Submission to the Australian Energy Regulator (AER)

**Response to proposals from Victorian electricity distribution
network service providers for a revenue reset for the financial
years 2022-2027 regulatory period**

**Brotherhood of St Laurence
Victorian Council of Social Service
Renew**

May 2020

Figure 1 - Average minutes without supply per customer (SAIDI)

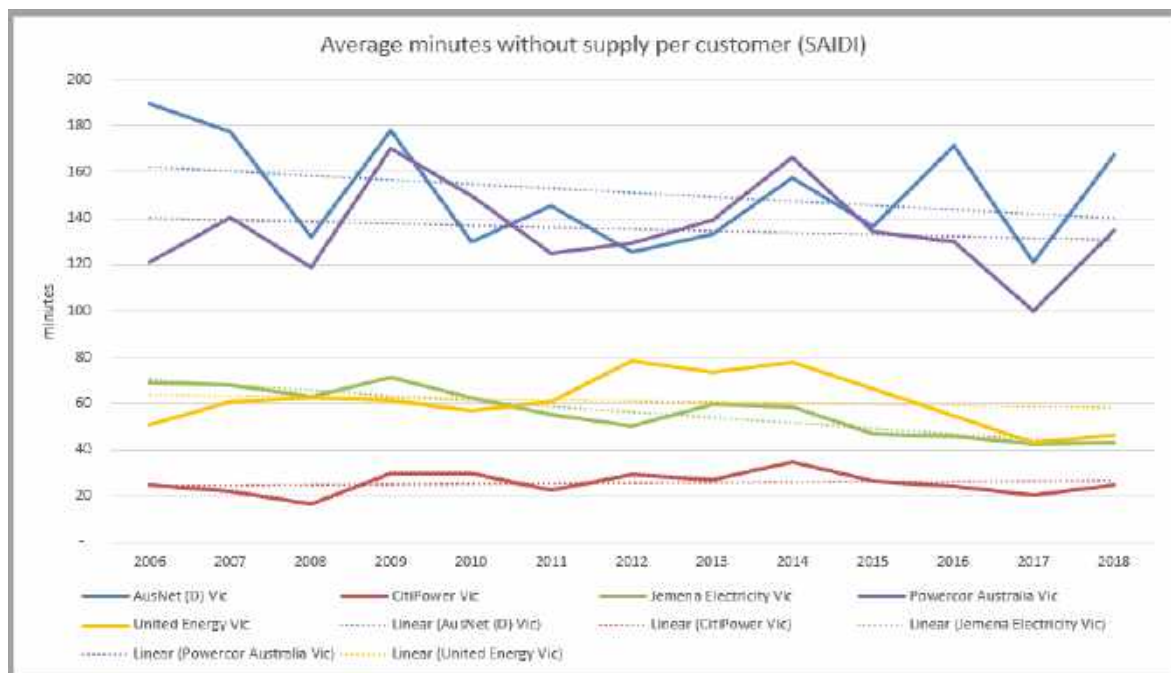
This demonstrates that all DBs have been committing funds to increase reliability for their customers, yet customers have been stating since before 2016 they would prefer lower costs to improved reliability. Not only have the DBs been devoting funds (particularly capital) to improving reliability, they have been gaining incentive payments for exceeding forecast reliability levels through their service target performance incentive scheme (STPIS).

Figure 3 – Asset utilisation

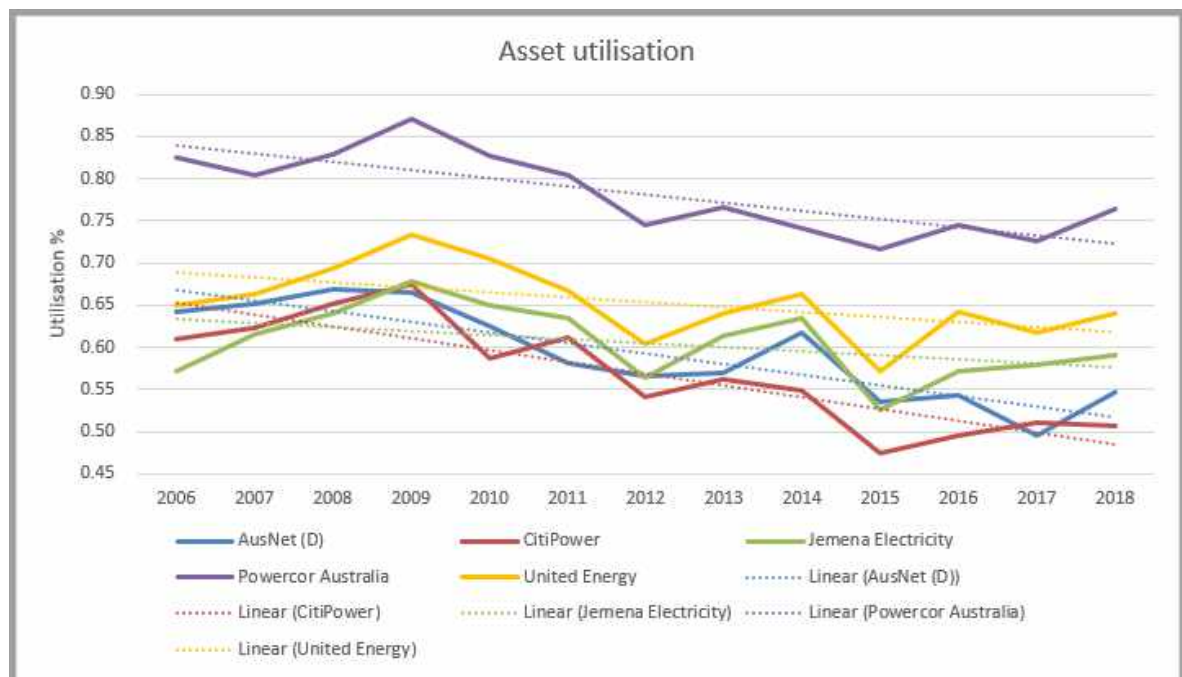
When combining the improving reliability with falling utilisation, this clearly highlights that the DBs are all increasing investment to provide assets and services that are not required

Figure 5 - Real revenue/consumption c/kWh

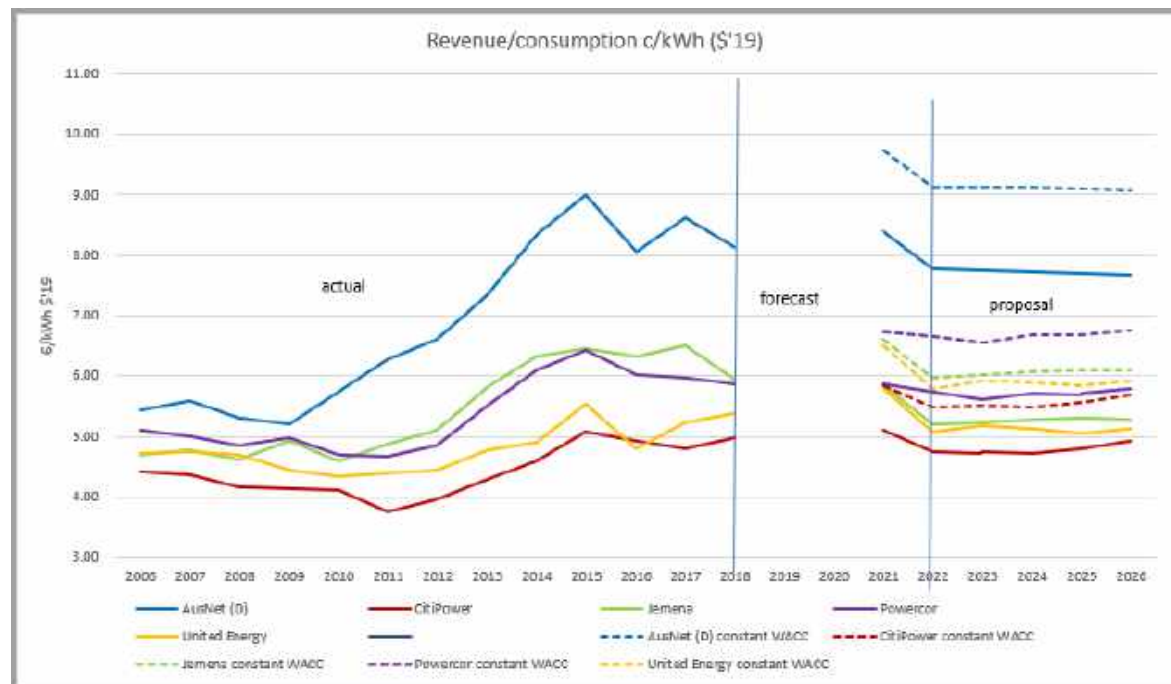
What this analysis shows is that despite the DBs all implying that they are reducing costs to provide the services, fundamental costs are increasing, and the only reduction that is occurring is the impact of exogeneous factors, specifically the falling cost of money.

Figure 6 Movement of real RAB over time

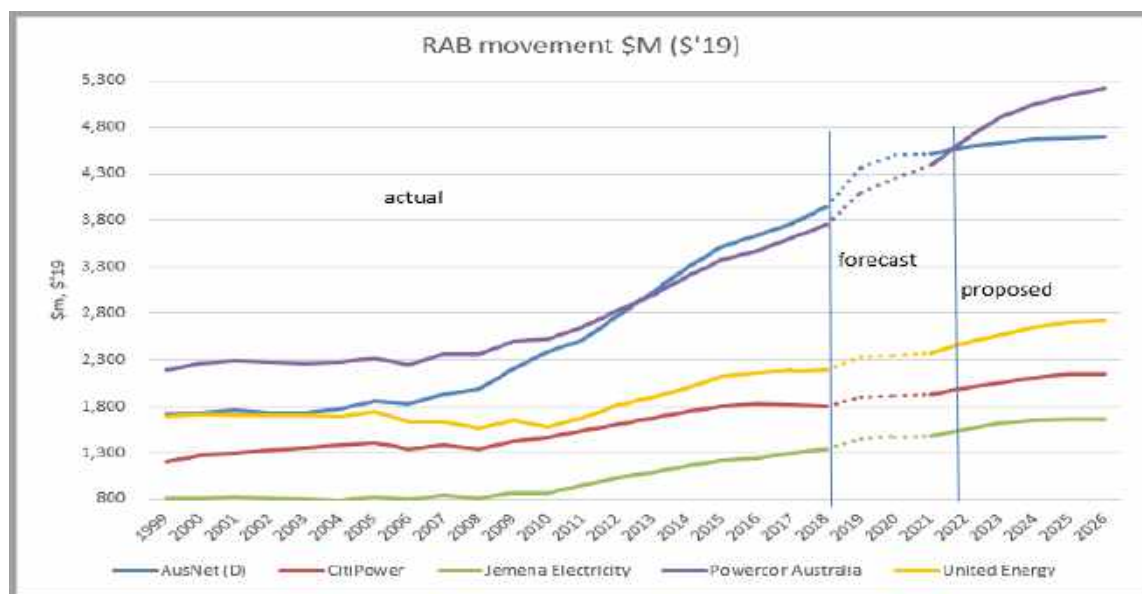
As an overarching assessment, the RAB for each of the five DBs has increased over time, and is forecast to increase further based on the DB proposals. This means that consumers will be faced with providing a return on this amount of money for decades to come. The sponsors recognise that the RAB growth alone is not necessarily an indication of whether the previous capital expenditure was inefficient, as it is expected that as the population grows and demand increases, the RAB would also have to increase. With this in mind, the sponsors have assessed the growth of the RAB in terms of customer numbers (figure 7) and peak demand (figure 8). The purpose of assessing RAB growth in terms of customers and peak demand is to generate an assessment in relative terms in order to eliminate the change in these drivers of RAB growth.

Figure 7 Movement of real RAB/customer over time

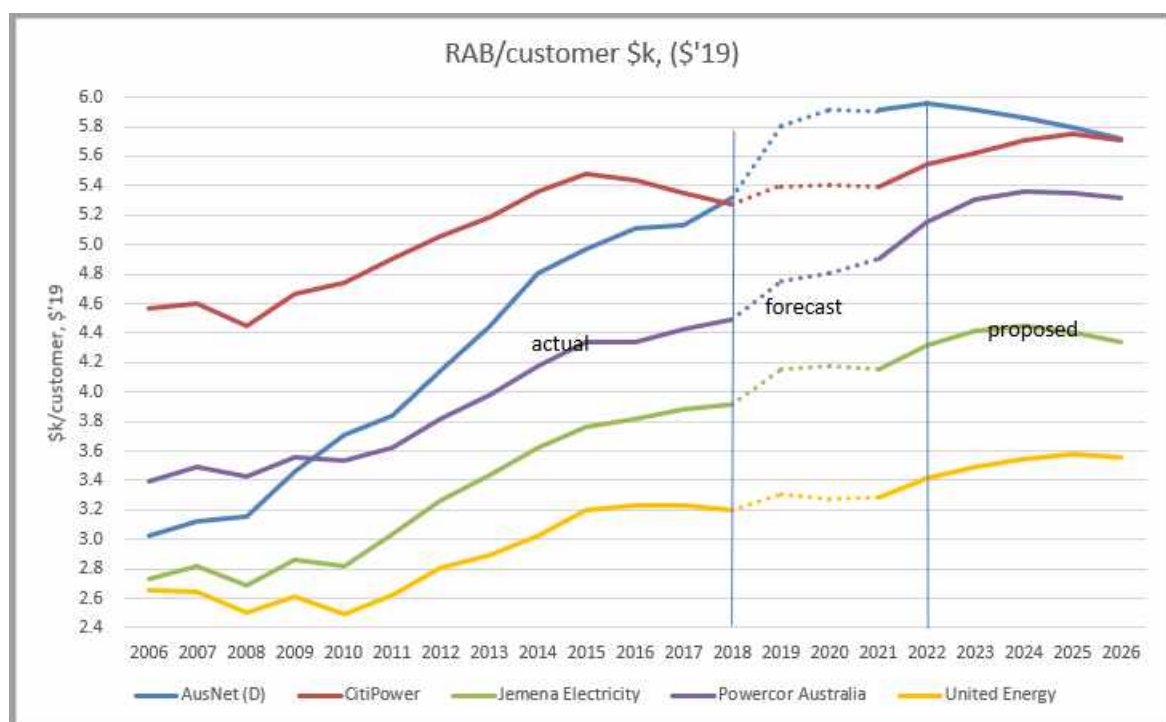
Compared to customer numbers, except for Ausnet, all DBs show quite modest growth in the RAB per customer from 2006 to 2010 (when the DBs were regulated by the regional regulator – Essential Services Commission of Victoria) and all show strong growth in the

RAB/customer from 2010 to 2018, with a modest degree of flattening out of this growth during the next period⁷.

Figure 8 Movement of real RAB/peak demand over time

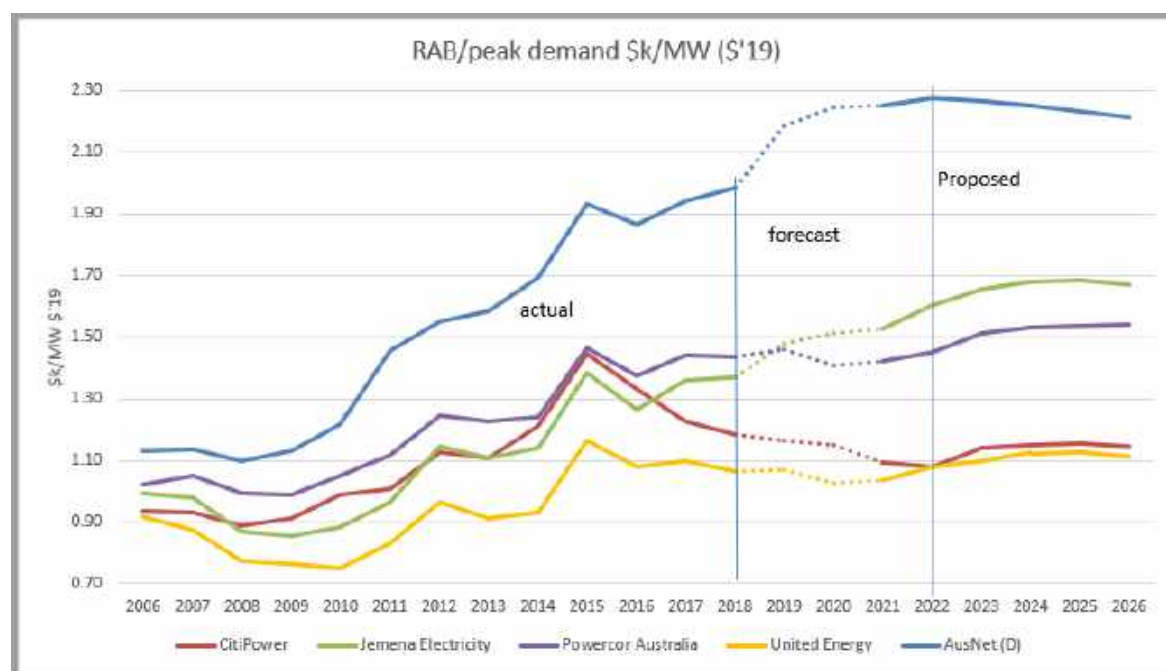
This analysis shows that some DBs have been able to reduce their RABs relative to peak demand, but all of them show a significant increase in the period 2011 to 2015. All DBs show that RAB/peak demand will either be flat or experience an increase in their proposals. However, if the peak demand forecast by the DBs does not eventuate, then this analysis implies that the DBs are continuing to inefficiently invest in assets not needed by consumers.

Figure 9 Movement of reliability relative of real RAB over time

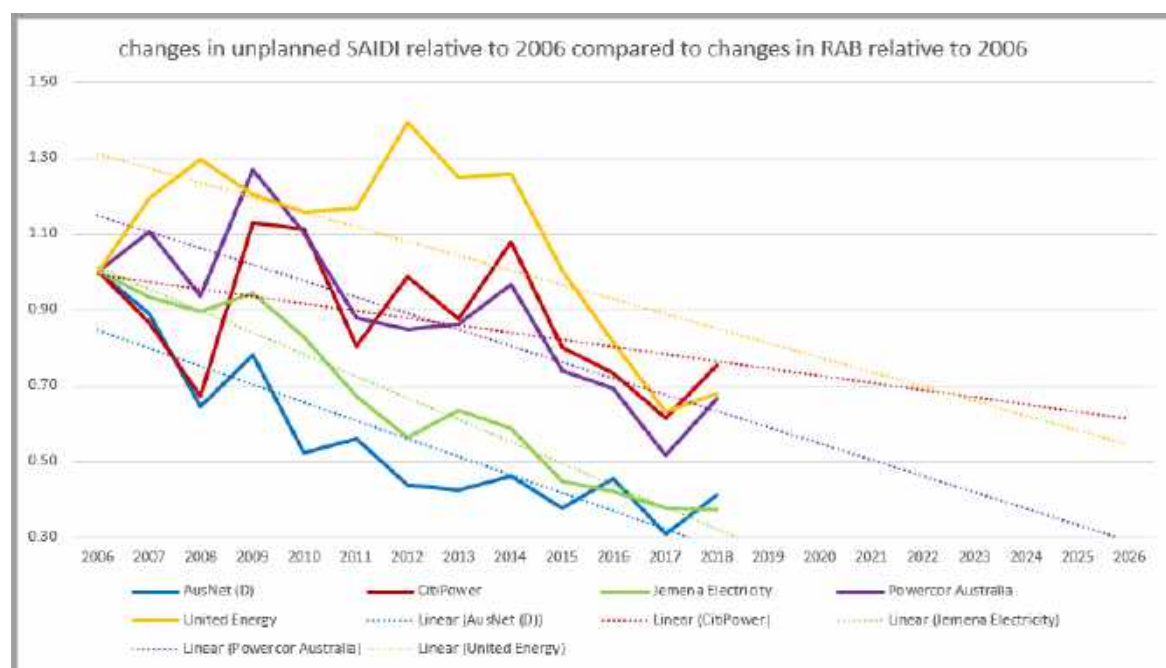
The chart (figure 9) shows the relative changes in SAIDI compared to the relative change in RAB. This clearly shows that the improvements in reliability have been associated with increasing RAB, which in turn imposes not only increased costs on current consumers, but consumers in the future as well. This identifies a critical aspect, in that the DBs have been able to improve reliability and so earn a Service Performance Target Incentive Scheme (STPIS) bonus through capex paid for by consumers.

Figure 10 Movement of real RAB over time relative to utilisation

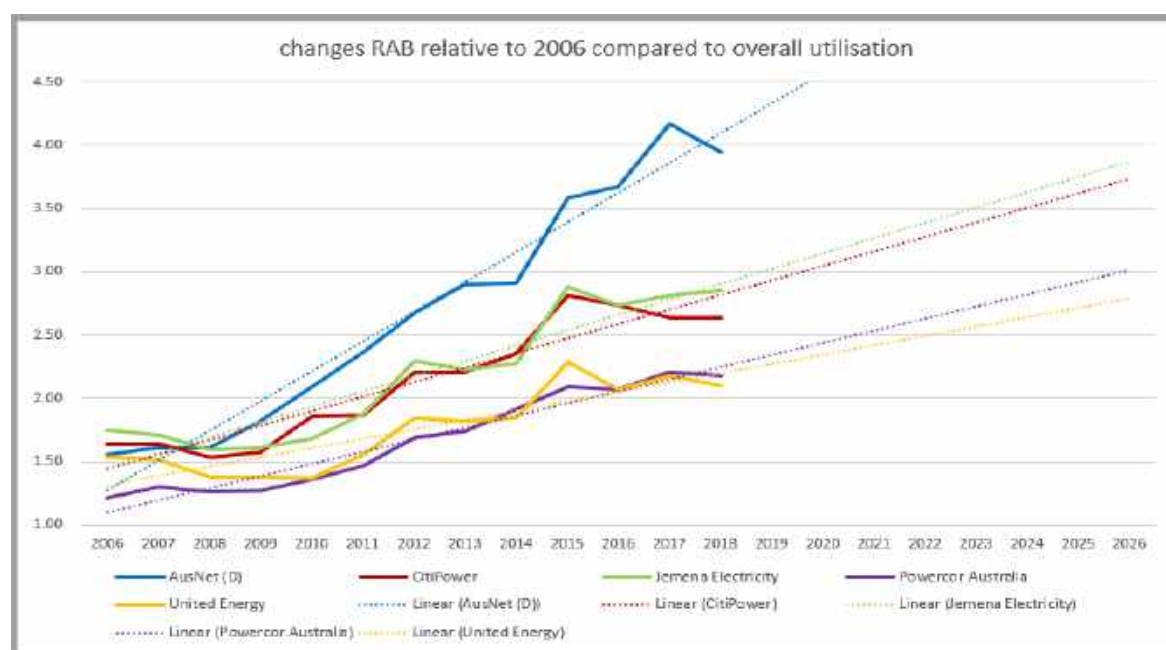
Figure 10 shows that there is also an association between the fall in utilisation and the growth in the in RAB, suggesting that consumers are funding assets beyond their needs.

Figure 11 Opex partial factor productivity

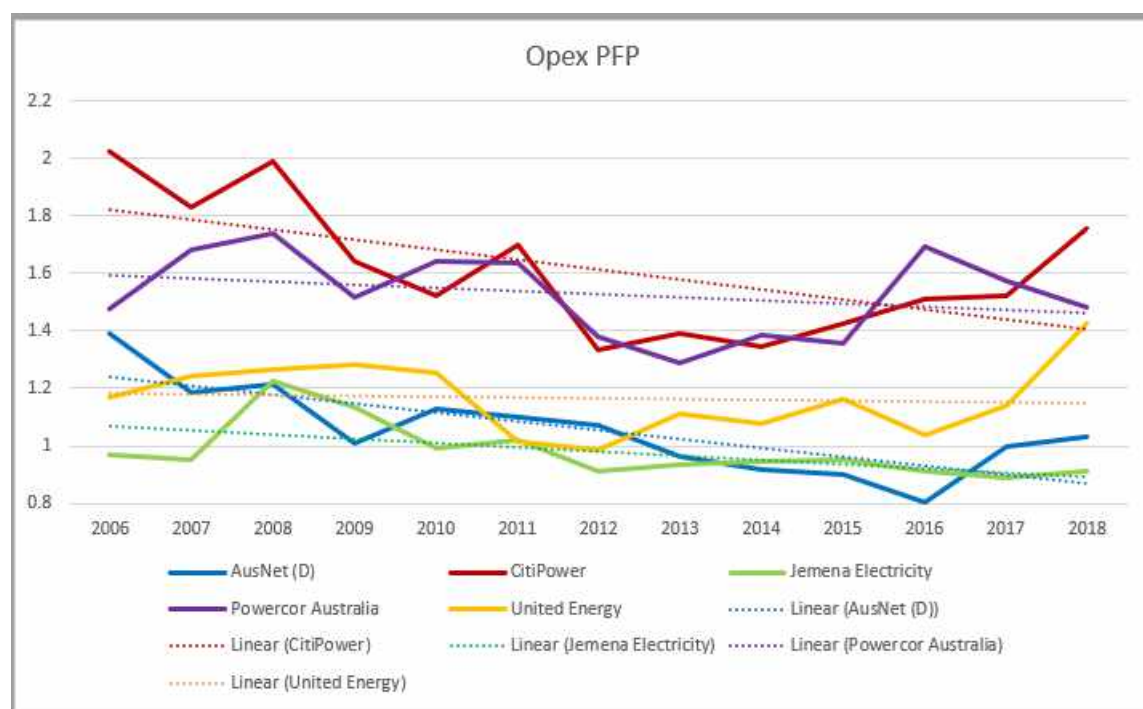
While the Economics Insights productivity series does show the relative productivity performance between the National Energy Market (NEM) distribution networks, it does not show the relative performance between regulated firms and those operating in a competitive market which would show whether the DBs are truly being fully incentivised by the opex incentive scheme.

That productivity shows a long-term downward trend implies that the opex incentive scheme is not achieving what true competition to the network firms would deliver to consumers. This then questions whether the use of the latest year actual opex is an appropriate starting point to set the opex for the next regulatory period. This issue is addressed in more detail in section 7 below.

Figure 12 – DNSP multilateral capital partial productivity indexes

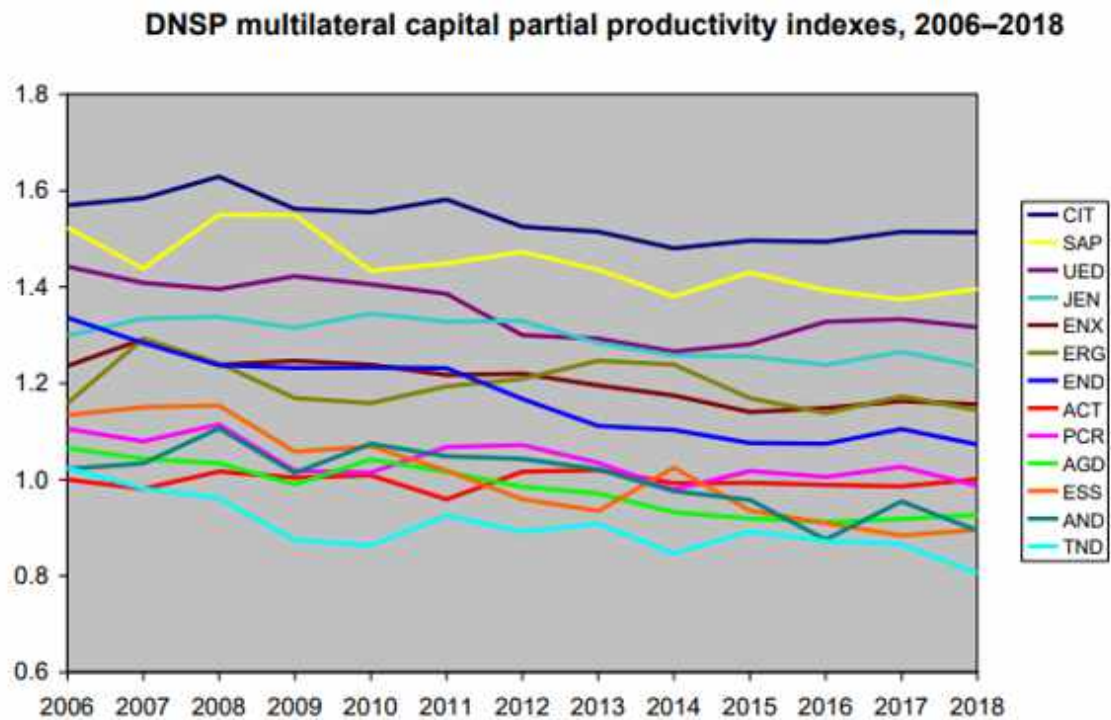
It is clear that few, if any, DB has improved its partial factor capex productivity over the period 2006-2018 but unfortunately Economic Insights does not provide the source data for this chart. What is apparent is that CitiPower shows the greatest capex productivity with Jemena and United showing lesser capex productivity with Powercor and AusNet showing similar but rather poor capex productivity, but all of them (with perhaps Jemena demonstrating this the least) show reducing capex productivity over the period 2006-2018.

Figure 13 Capex partial productivity factor index for Vic DBs

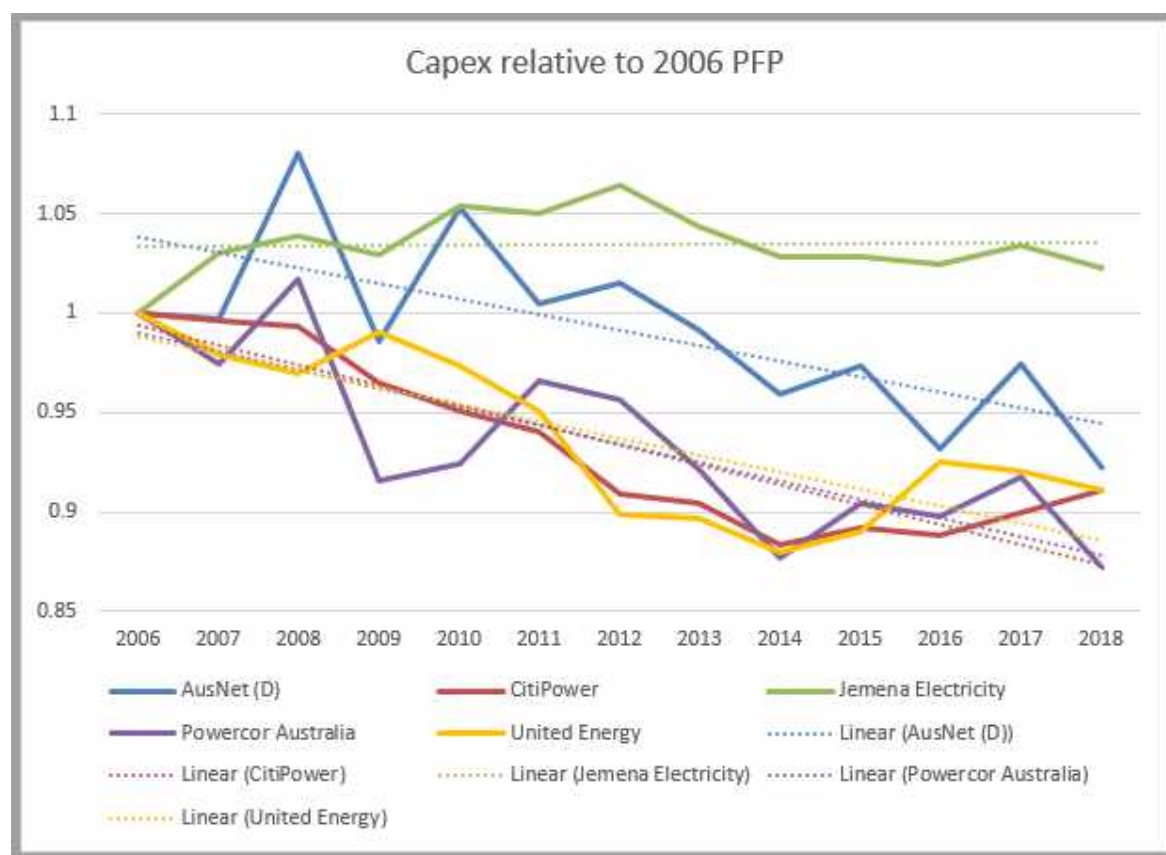
This chart reinforces the view derived from Economic Insights' findings that the trends over time show that all DBs (except perhaps Jemena) have quite severely falling capex productivity. This trend reflects the view expressed in section 3.1 above that previous capex has not been efficient.

Figure 14 Network customer numbers

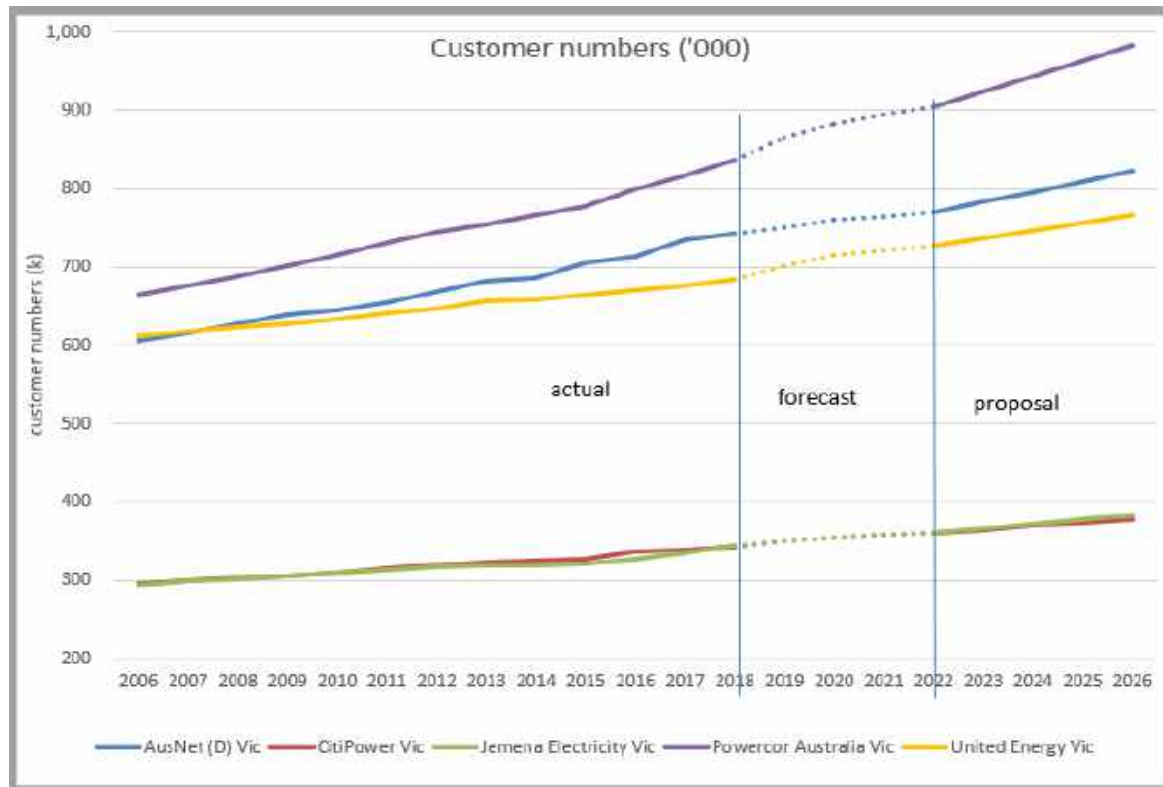
Whilst the growth in customer numbers reasonably follows the historical trends for CitiPower and Jemena, the growth forecasts for AusNet, Powercor and United all show a distinct upward trend from 2018 to 2020 and then a faster growth rate during the forecast period and an even faster growth rate included in the proposals.
